SUNOCO ENERGY DEVELOPMENT COMPANY
SAGE POINT-DUGOUT CANYON MINE

Application for SMCRA Permit Approval and Mining Plan

OSM
FINDINGS
SUNOCO ENERGY DEVELOPMENT COMPANY
SAGE POINT-DUGOUT CANYON MINE

Application for SMCRA Permit and Mining Plan Approval

Map 1 - Fish Creek Raptor Nest Sites

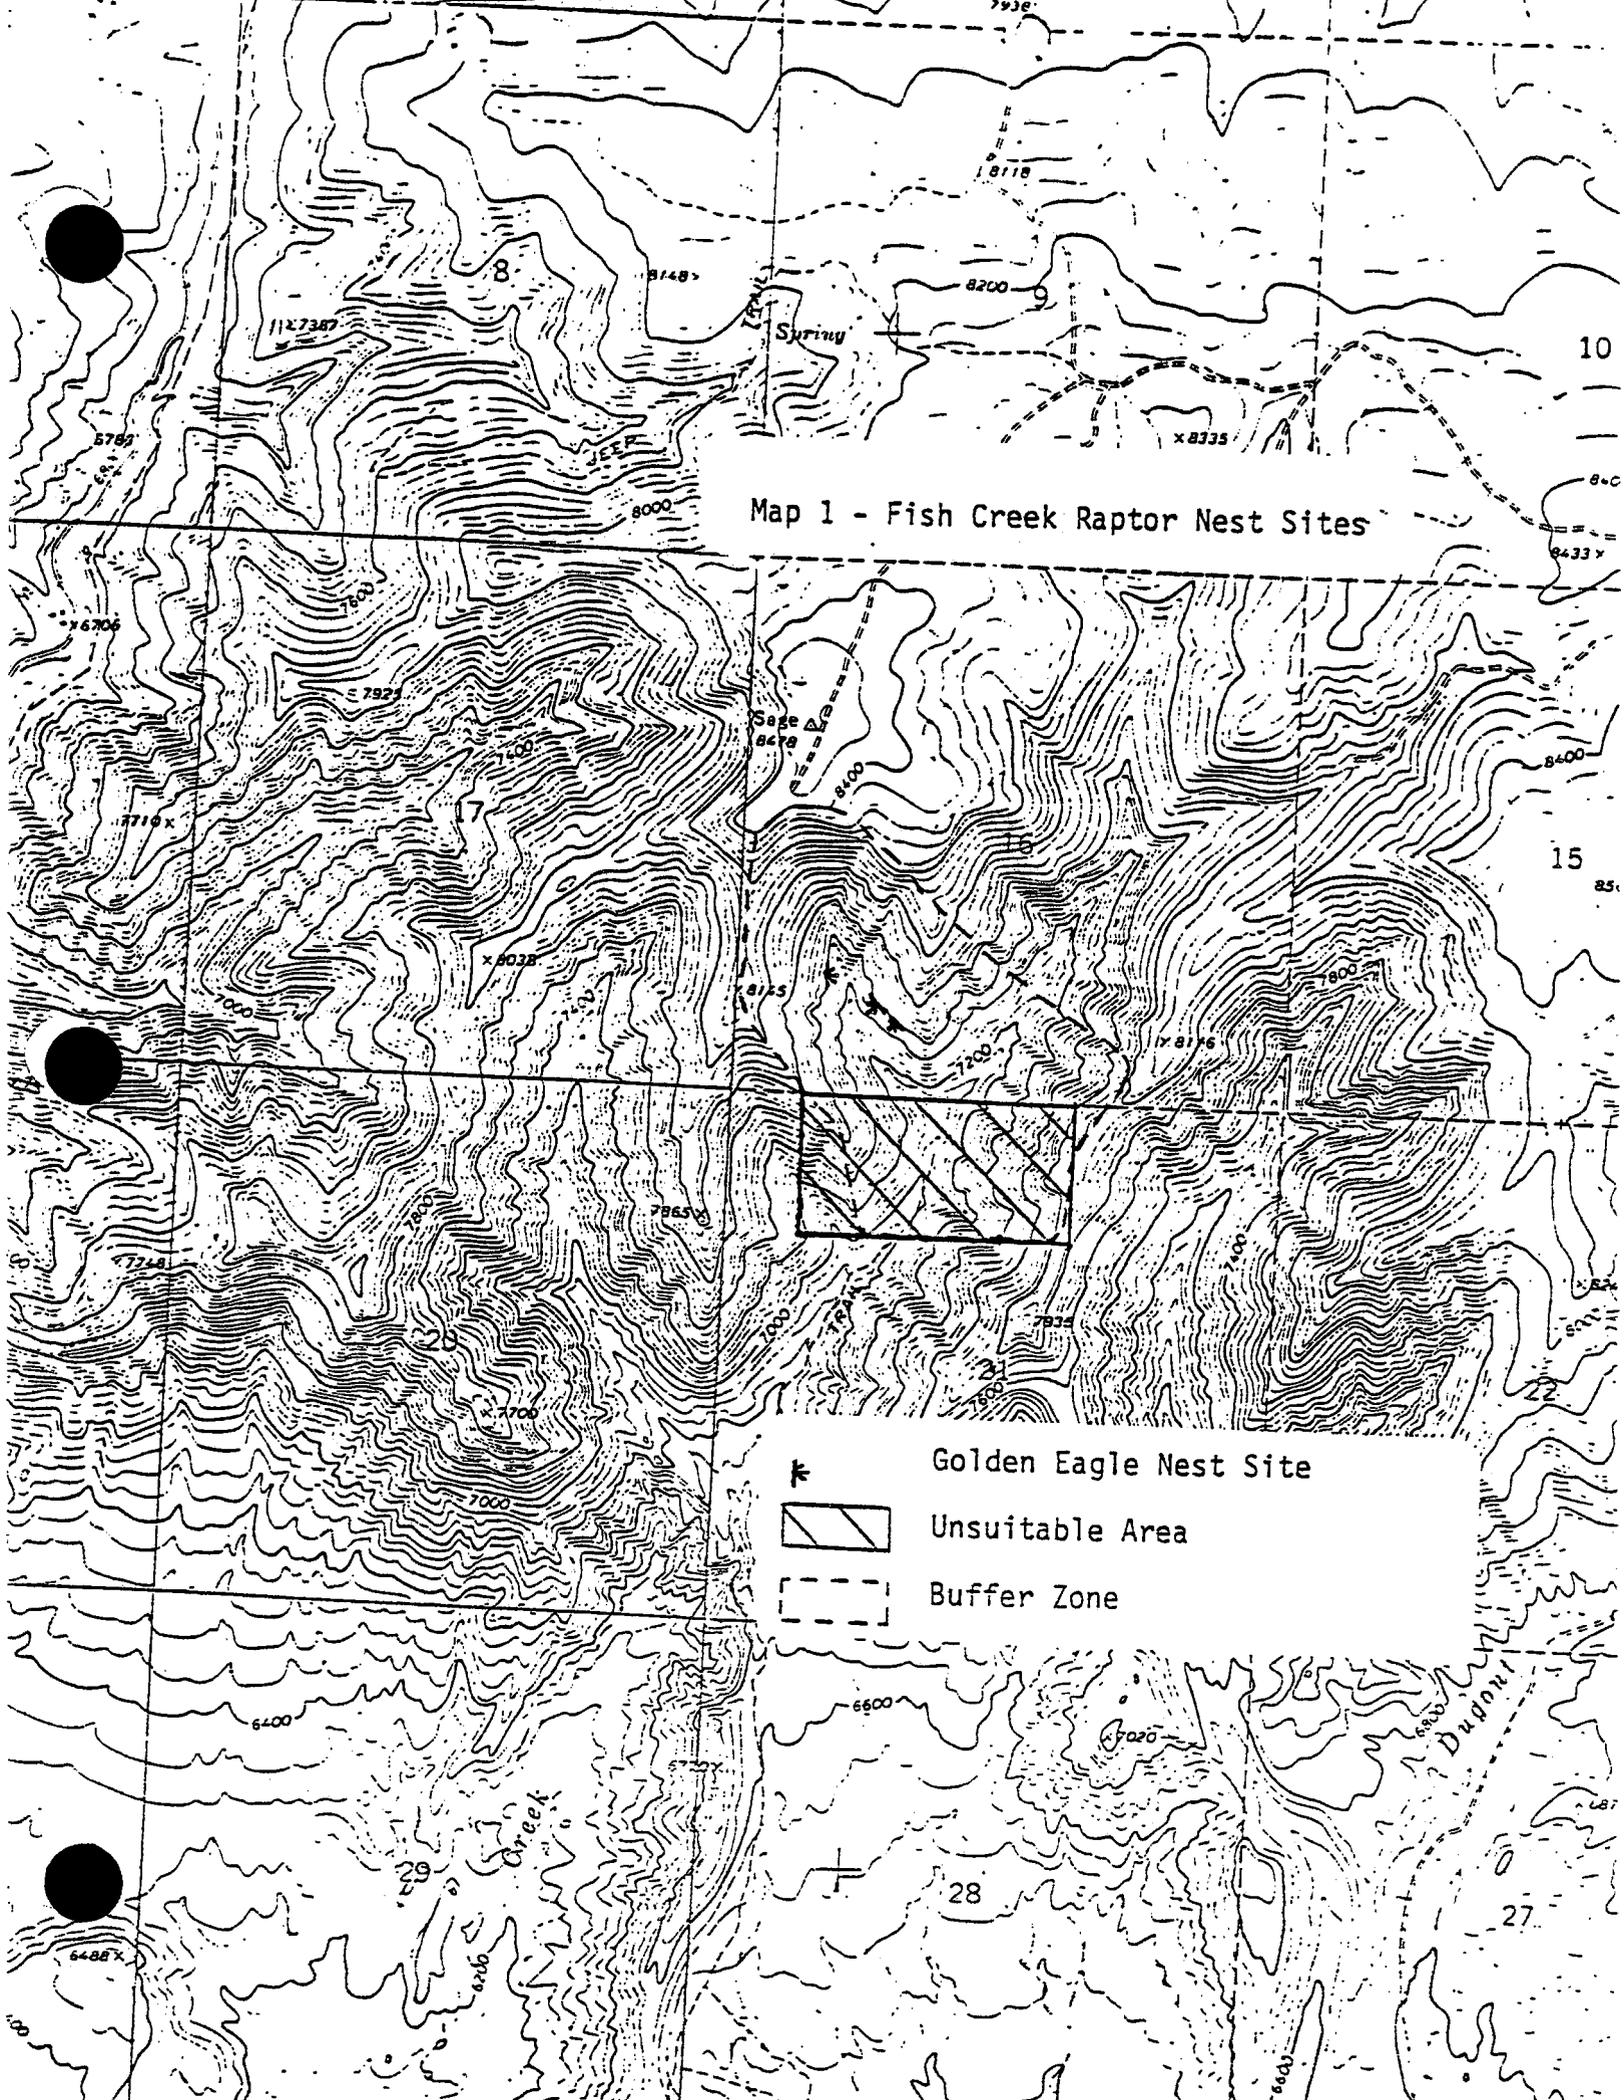
Change 2 - Rewrite second sentence: "A buffer zone, shown on map 1, has been established for protection of these nest sites within which the following mitigating measures apply:"

Map 3 - Dugout Canyon Cooper's Hawk Nests

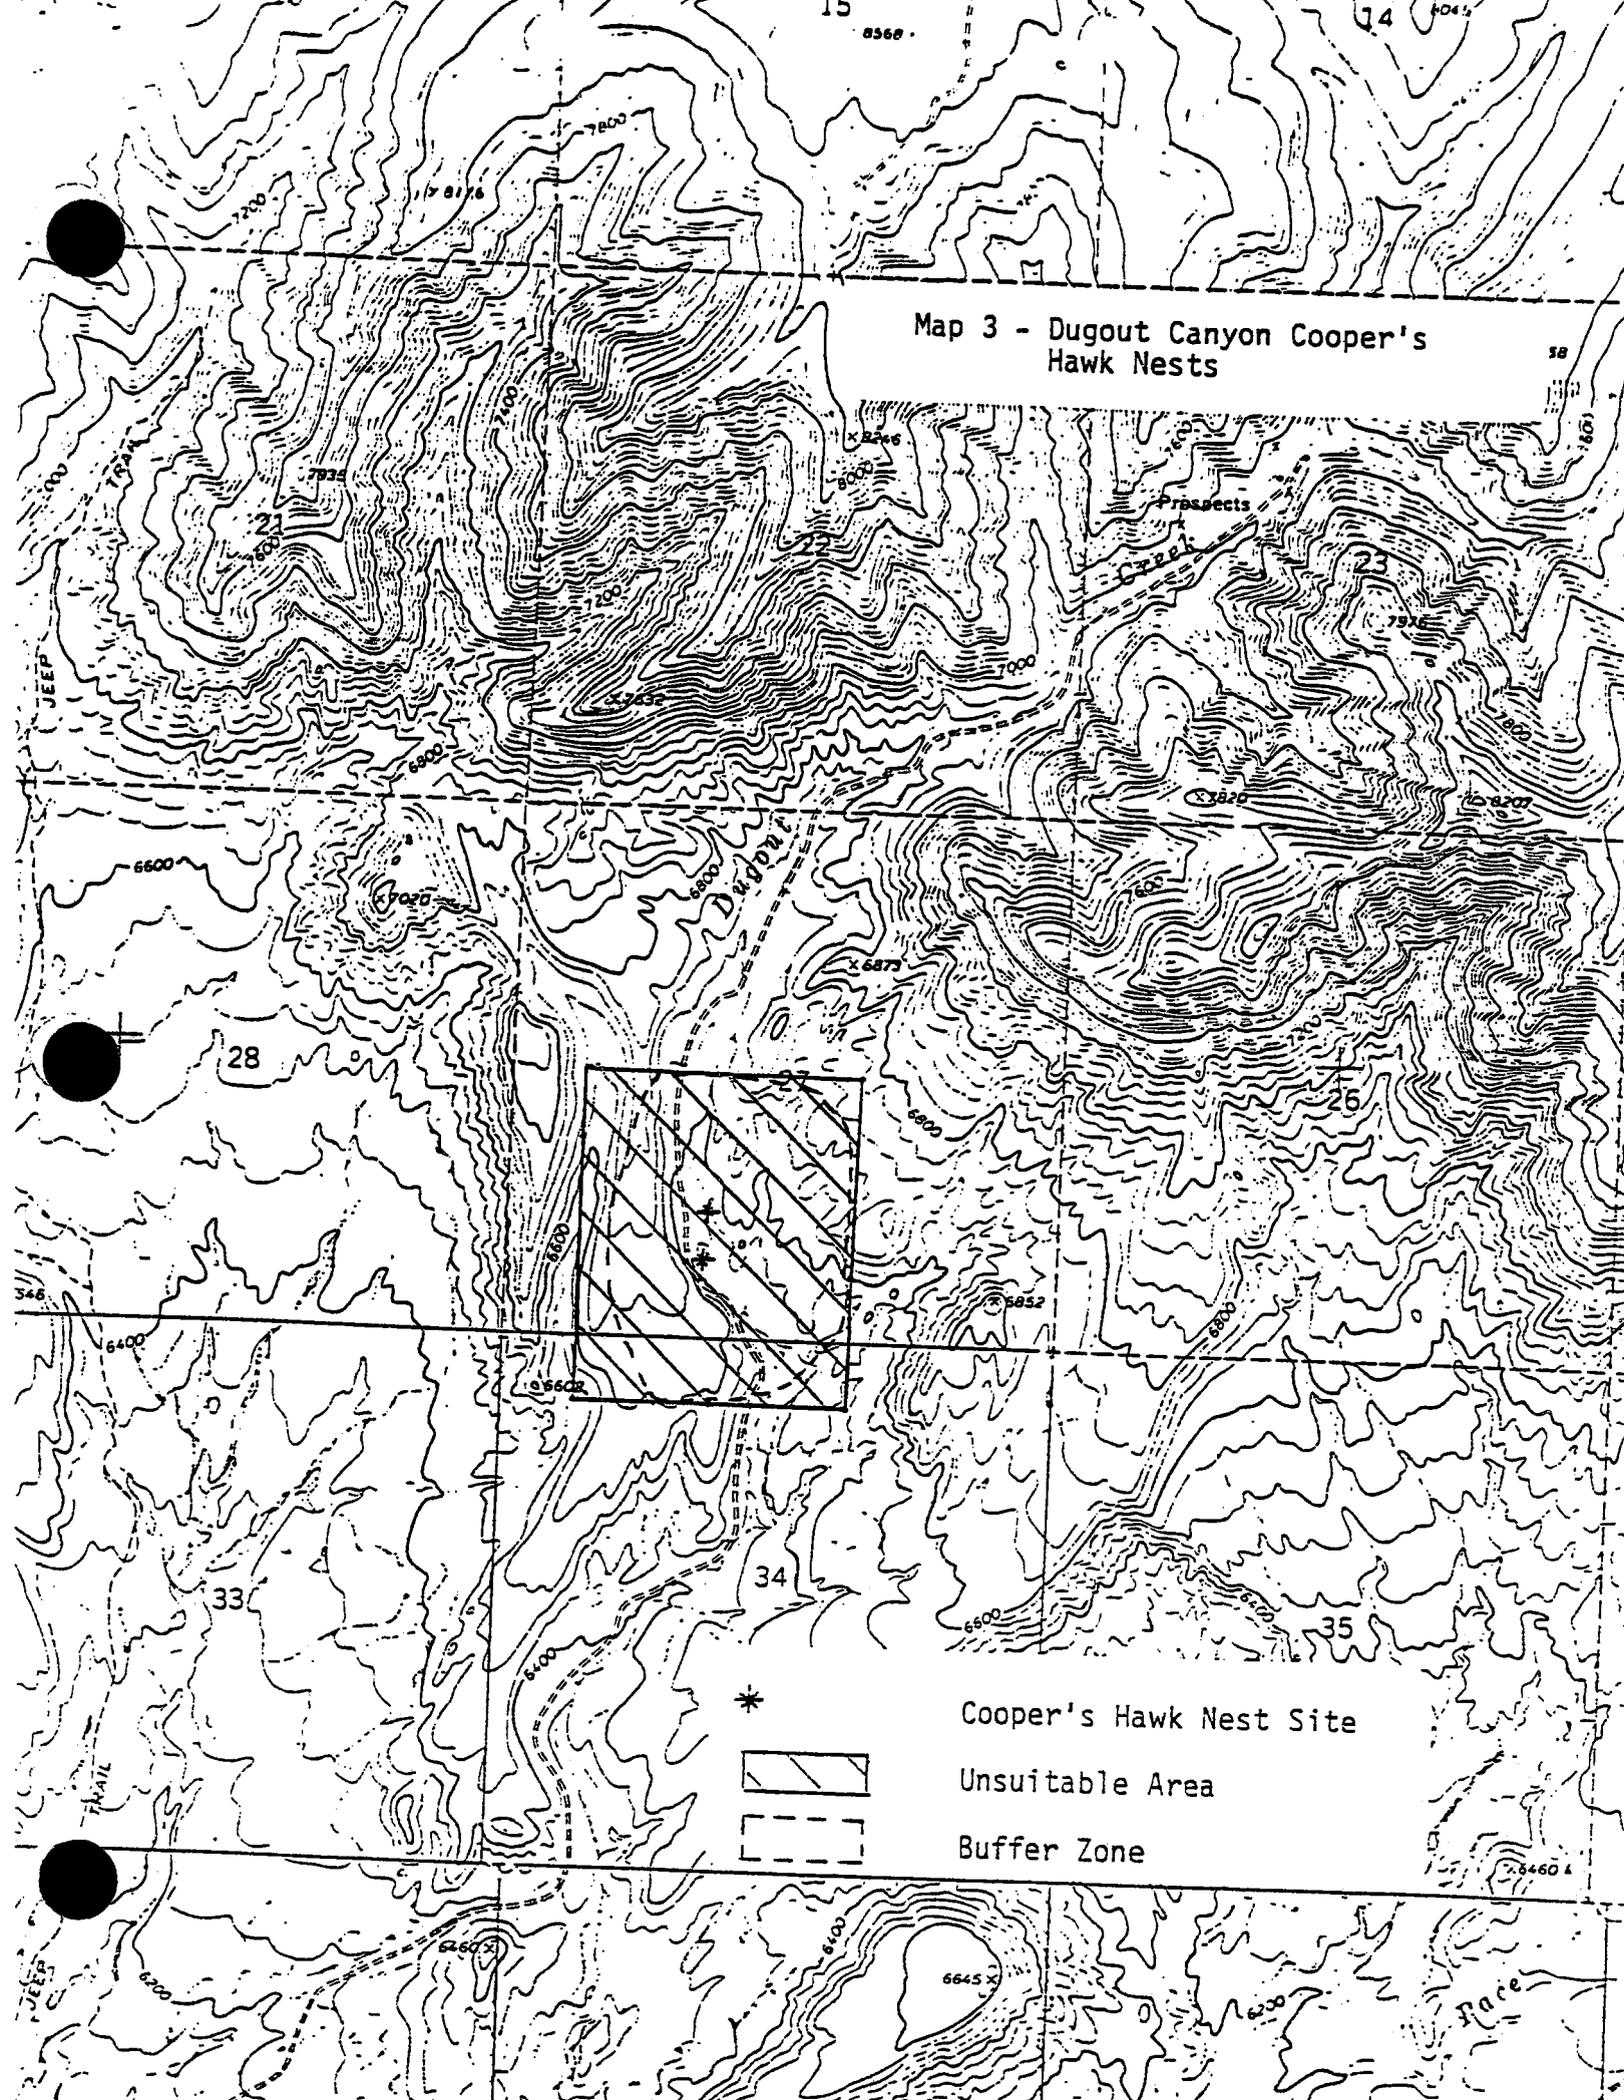
Change 4 - Rewrite second sentence: "A buffer zone, shown on map 3, has been established for protection of these nest sites within which the following mitigating measures apply:"

Figure 4. Raptor Nest Buffer Zones

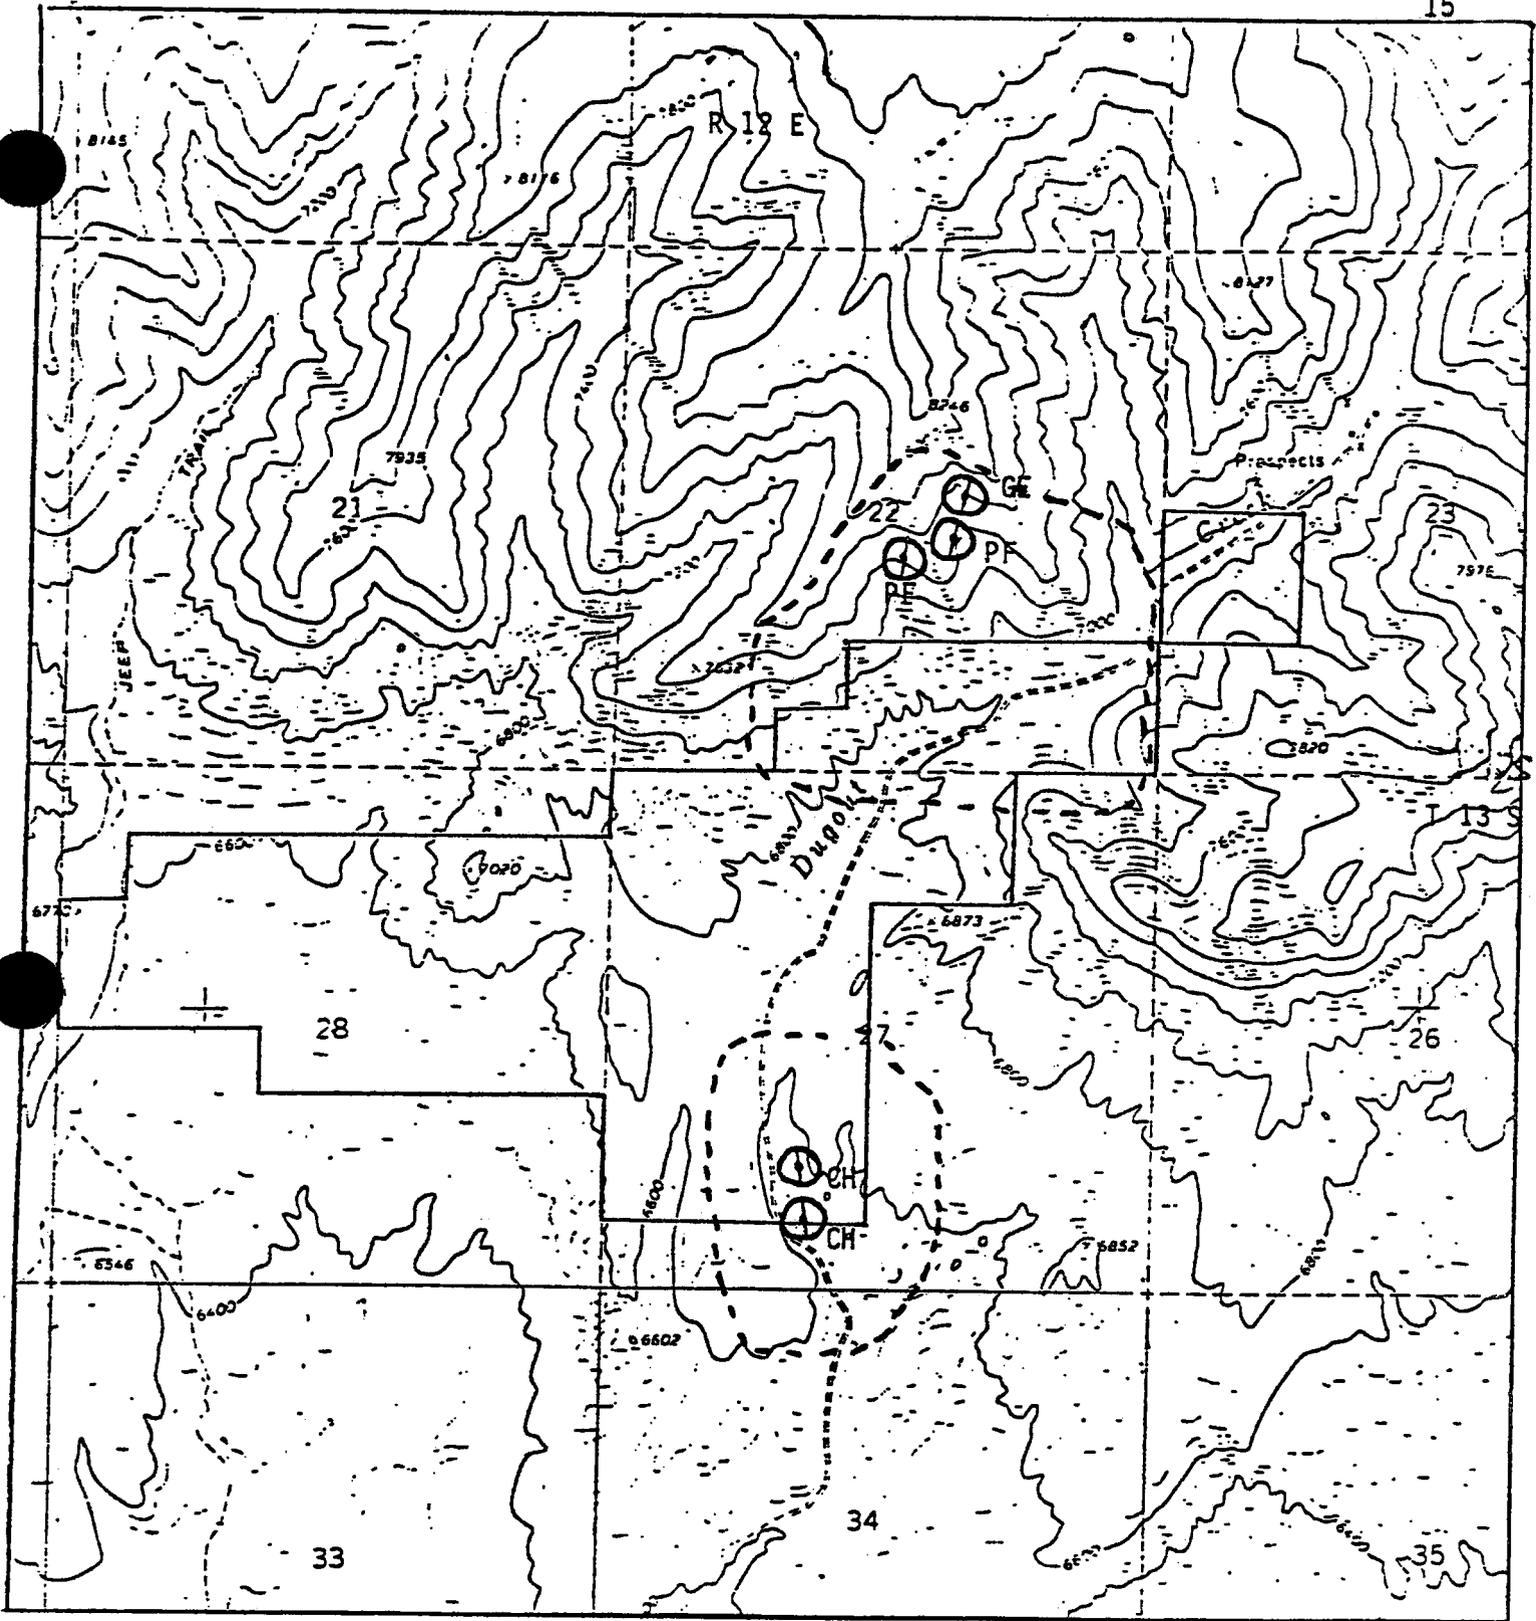
Q. Two Cooper's hawk nests have been documented as active by the BLM and the UDWR. A buffer zone established for the protection of these nest sites is outlined on Figure 4 (attached) and is unsuitable under Criterion 13. An exception can be applied with the following stipulations:

R. One active prairie falcon eyrie, one suspected prairie falcon eyrie and one golden eagle nest site (old) were documented by the FWS and the UDWR. A buffer zone delineated on Figure 4 identifies the area considered unsuitable according to Criteria 11 and 13 of the Unsuitability Criteria. An exception can be applied to allow limited surface disturbance based on the following stipulations:

- 1. Surface construction activities may be prohibited within the buffer zone (Figure 4) during the critical nesting period, March 15 to June 15. Surface construction may be initiated on June 1 if a nesting attempt has not been documented by the lessor in consultation with the FWS. Surface construction may also be initiated on June 1 if a determination by the lessor, in consultation with the FWS, shows the nesting attempt to be nonproductive. This determination
